**FINDINGS AND RECOMMENDATION
OFFICE OF PLANNING AND ZONING
ANNE ARUNDEL COUNTY, MARYLAND**

CASE NUMBER: 2024-0061-V

The applicants are requesting variances to allow dwelling additions (living space and deck¹) with less setbacks and buffer than required and with disturbance to slopes of 15% or greater on property located at 714 Skywater Road in Gibson Island.

0.04
PROPOSED SITE

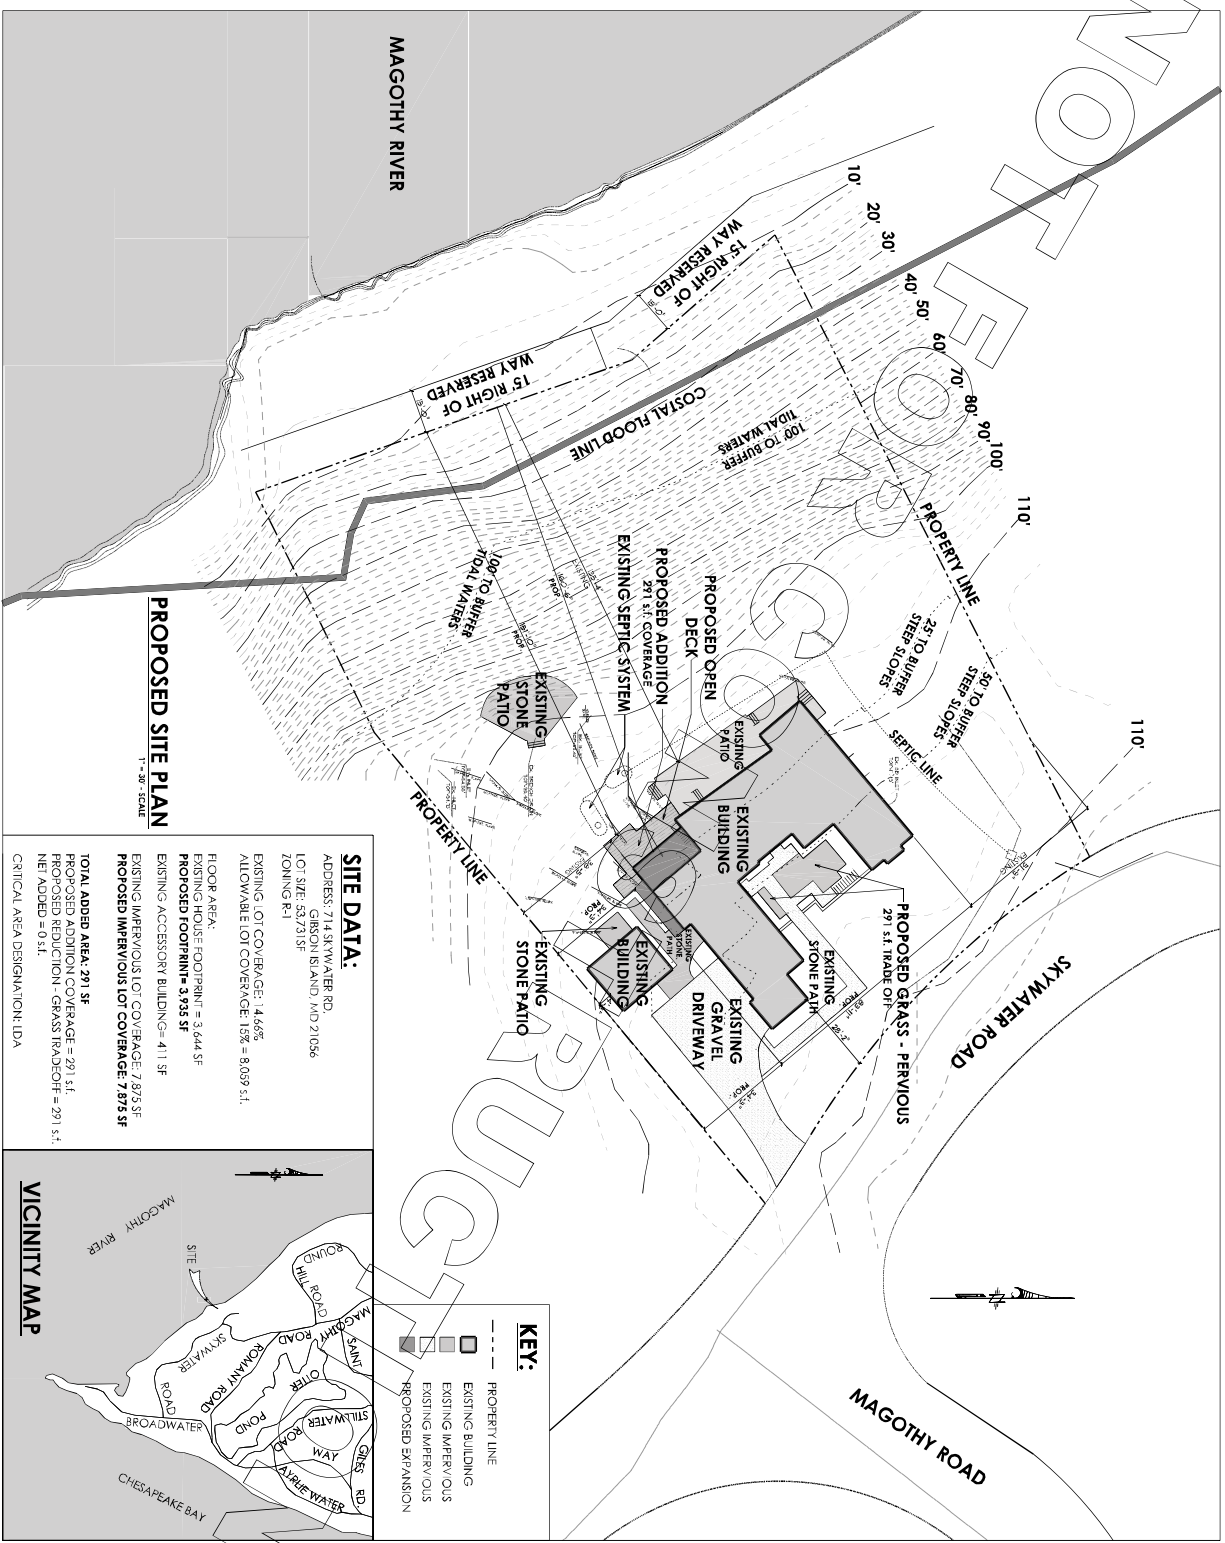
The **Development Division (Critical Area Team)** commented that the existing home has 4,623 square feet of habitable space with a 3,644 square foot footprint. Although the addition is minimal, the applicants have not adequately demonstrated why the needed renovations could not occur within the existing footprint, eliminating the need for the variance altogether. The applicants will need to provide this information to demonstrate that the proposed request meets the test for the minimum necessary to

afford relief. The proposed deck expansion cannot be supported. There are ample outdoor amenities; and, although the Code provides for access to the water, it does not provide for access to a view. The applicants' application of the exemption for lot coverage for direct water access is incorrect. This site could be subject to the 10% reduction requirement for sites that exceed the lot coverage limitations. This will be determined at permitting and will need to be addressed prior to permit approval.

As proposed, the Critical Area Commission opposes this variance request as this request does not meet all of the Critical Area variance standards, including that of unwarranted hardship. Furthermore, impacts to sensitive environmental features such as the Critical Area Buffer and steep slopes have not been minimized. State law defines "unwarranted hardship" to mean that, without the requested variance, an applicant shall be denied reasonable and significant use of the entire parcel or lot. It does not appear that this request can meet this variance standard as the applicant currently has reasonable and significant use of the entire property with the dwelling, patios, accessory building, courtyard, and walkways. While the applicant indicates that they cannot access the existing patio via a wheelchair with the current layout, it appears that the applicants are also proposing major and structural renovations inside the existing footprint of the home such as relocating stairs located within the kitchen to flank the south side of the dwelling. The documentation provided does not detail alternative analysis to show that the current request is the only viable design to provide wheelchair access to outdoor recreational areas (existing and proposed). Nevertheless, if the request to construct a three story, 291-square foot addition and a 300-square foot deck were to be denied, the applicant would still have reasonable and significant use of the entire lot or parcel with the existing improvements. Additionally, the County's Critical Area program and the State Critical Area regulations place strict limits on disturbance to the Critical Area Buffer, steep slopes, and the steep slope buffer in order to meet the goals of the Critical Area law. Approving a variance to allow steep slope and Critical Area Buffer disturbance for the construction of approximately 600 square feet of additional improvements when there appears to be opportunities to renovate the existing footprint of the home to provide the desired accommodations, and when there are already expansive areas used for outdoor recreational use, is not a right commonly enjoyed by other, similar properties developed under the County's Critical Area program. No property owner has the right to disturb steep slopes and the Critical Area Buffer in order to provide expanded living and outdoor recreational space when the property owner already enjoys over 4,623 square feet of existing habitable space and expansive outdoor areas.

Denying the request to construct the 291 square foot addition and 300 square foot deck in the Critical Area Buffer and within steep slopes is not depriving the applicant of a use that would be permitted to others under the local Critical Area program. Conversely, the granting of this variance would absolutely confer a special privilege upon the applicant. The Anne Arundel County Code and the Critical Area regulations place strict limits on disturbance to steep slopes and to the Critical Area Buffer in order to meet the goals of the Critical Area law. Approval of this variance would grant the applicant a special privilege that would be denied others within the Critical Area, as no individual is permitted to construct an addition and deck within the Buffer with no proof that this request is required to provide reasonable accommodations and when a site is already improved with expansive habitable space and outdoor/recreational areas. The Critical Area Commission has previously opposed similar variance requests from others; therefore, granting this applicant's request would confer upon the applicant a special privilege denied to others. Further, the cumulative impact of development in the Critical Area has a substantial and negative impact on the Chesapeake Bay. Given the lot is waterfront to the Magothy River and the request is for additional lot coverage on steep slopes and within the Critical Area Buffer, this request is not in harmony with the spirit and intent of the Critical Area law and regulations or the County's Critical Area program. Lastly, the request to construct the dwelling addition and deck at the top of steep slopes and within the Critical Area buffer can increase the volume and velocity of stormwater runoff flowing down the steep slopes. Especially given that the applicant already enjoys expansive habitable and outdoor amenities within the Critical Area Buffer and on steep slopes, this request will absolutely have an adverse effect on water quality and habitat within the Critical Area. For the reasons explained above, the Critical Area Commission opposes this variance and recommends denial of this request.

Based upon the standards set forth in § 18-16-305 of the Code under which a variance may be granted, this Office recommends *denial* of the proposed Critical Area variances to § 17-8-301 and § 17-8-201(a). Should the Administrative Hearing Officer determine that variance relief is warranted, any approval must be conditioned on the proposal satisfying the Cultural Resources Section reviewer(s) in accordance with Section 17-6-501 of the Code at the time of permitting.
